Access Compliance Report

Public Rights-of-Way

(Curb Ramps)

Intersection ID: 11619	Main Street: E_15TH_ST	Cross Street: N_CALDWELL_ST	Location: W
ADA ID: 7C1197036556	Ramp Type: PerpDiag	Initial Pass/Fail: Fail	Overall Compliance: No
		Severity Score: 35

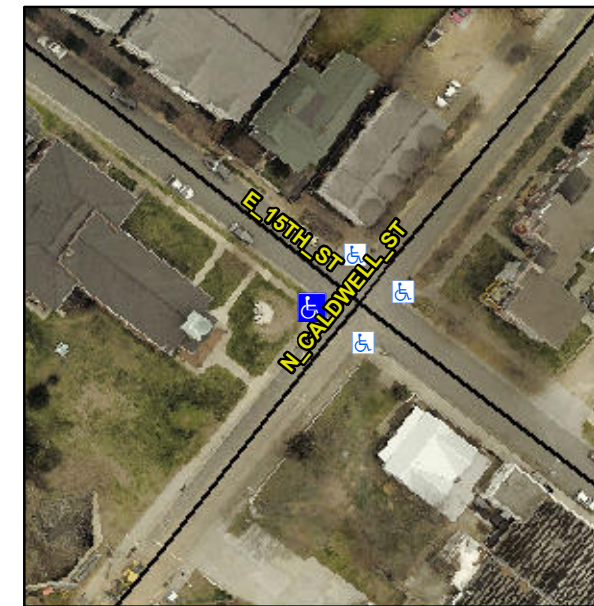
Not Found, R304.5.1

Compliance	Description	Data	Compliance	Description	Data
N/A	Ramp Length (in)	48.0	Yes	Ramp Slope (%)	7.6
No	Ramp Width (in)	30.0	Yes	Ramp XSlope (%)	0.1
N/A	Flare Type LT	N/A	N/A	Flare Type RT	N/A
N/A	Flare Slope LT (%)	N/A	N/A	Flare Slope RT (%)	N/A
N/A	Flare Traversable LT?	N/A	N/A	Flare Traversable RT?	N/A
N/A	Landing Length (in)	N/A	N/A	DWS Provided?	N/A
N/A	Landing Width (in)	N/A	N/A	DWS Contrast?	N/A
N/A	Landing Slope (%)	N/A	N/A	DWS Length (in)	N/A
N/A	Landing X Slope (%)	N/A	N/A	DWS Full Width?	N/A
N/A	Landing Curb? (Y/N)	N/A	N/A	DWS Offset (in)	N/A
N/A	Shared Landing?	N/A			
N/A	Gutter Ponding?	N/A	N/A	Gutter Slope (%)	N/A
N/A	Gutter Lip Ht (in)	N/A	N/A	Gutter X Slope (%)	N/A
N/A	Painted X Walk1?	No	N/A	Painted X Walk2?	No
	X Walk 1 Direction	To SE		X Walk 2 Direction	To NE
N/A	X Walk 1 Width (in)	N/A	N/A	X Walk 2 Width (in)	N/A
	X Walk 1 Slope (%)	7.4		X Walk 2 Slope (%)	10.5
	X Walk 1 X Slope (%)	6.8		X Walk 2 X Slope (%)	4.8

Remove & Replace Curb Ramp With Two New Directional Ramps or Equivalent.
